LONDON BOROUGH OF ENFIELD

PLANNING COMMITTEE

Application Number : TP/10/0002

PROPOSAL: Subdivision of site and erection of an end of terrace 2-storey, 2-bed dwellinghouse.

Proposed Street Elevation

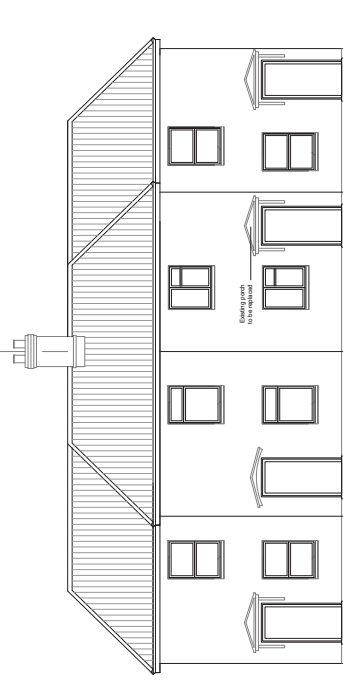
- 6.2.8 The dwelling, whilst of a similar sized frontage to that of No.15, would be built up to the common boundary with the public house, thereby occupying all of the space to the side. This would again be similar to the development at 17A but as discussed above, the starting point for that development differs. One of the characteristics of the current dwelling is the open spacious gap to the common boundary with the public house albeit behind a high boundary wall. In addition, in this instance, the historic curtilage will be subdivided and with the side garden/ space to the side forming an integral part of the dwelling of recognised historic value, its character and setting are further compromised

- 6.2.12 In addition, whilst it would have been more preferable for the ridge height to have been subservient to the existing dwelling thereby emphasising the dominance and importance of that original building, it would be difficult to resist the ridge height as proposed because it would be similar to the height of the development at 17A.

- 6.2.13 The detailing of the windows on the front elevation of the three existing dwellings is a mismatch, a result of permitted development that could be carried out until the recent Article 4(2) Direction. Although the proposed windows do not match those on the existing dwelling at No.15, they do match the style of windows at No.17A. It could again be argued that the proposed windows would re-balance the small group of houses. In addition, the porch is a feature of the existing three dwellings and it is considered that it would be difficult to resist this element.

Proposed Ground Floor Plans

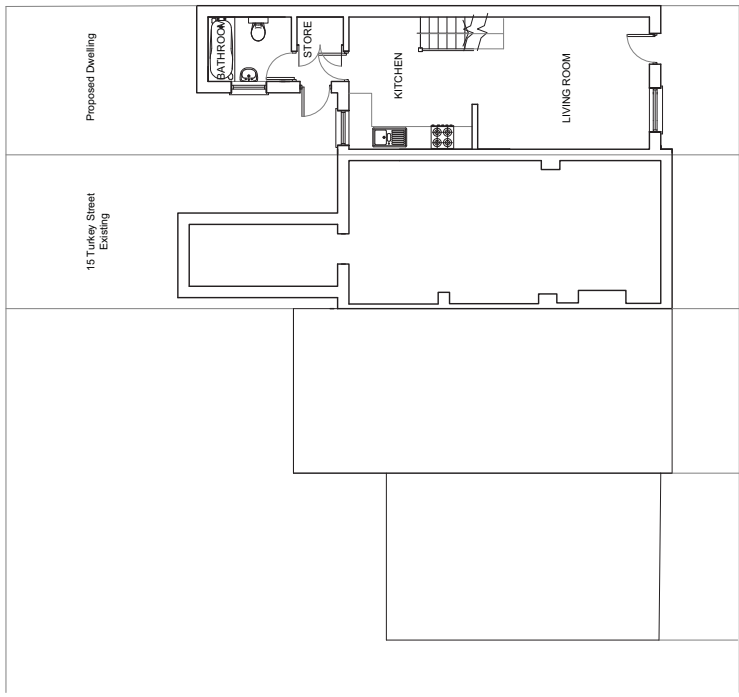
- 6.3.3 The ground floor of the proposed dwelling has a 3.8m deep projection (containing a store room and a bathroom) on the boundary with the public house, and a 1.65m separation to the boundary that will be formed with the existing dwelling. Two windows serving a kitchen will be affected should the development proceed. The primary (larger) window is sited on the north elevation and a secondary window on the flank will be lost completely. At present, due to the orientation of the dwelling, the majority of natural light

- 6.3.4 The depth of the store room / bathroom projection will compromise a 45-degree line taken from the midpoint of the retained kitchen window on the existing dwelling by approximately 1.1m. This is considered to lead to a detrimental loss of outlook.
- 6.3.5 In addition, a boundary fence would be formed along the common boundary which could potentially be up to 2m in height and within 0.4m of the retained kitchen window. The potential boundary fence height would result in less than 0.3m of the window above fence level thereby further impacting on natural light reaching the kitchen as well as leading to a greater sense of enclosure.
- 6.3.6 Any potential for overlooking and loss of privacy into the rear garden of No.15 would be no worse than the existing situation between Nos.15 & 17. In this respect, no objections are raised.
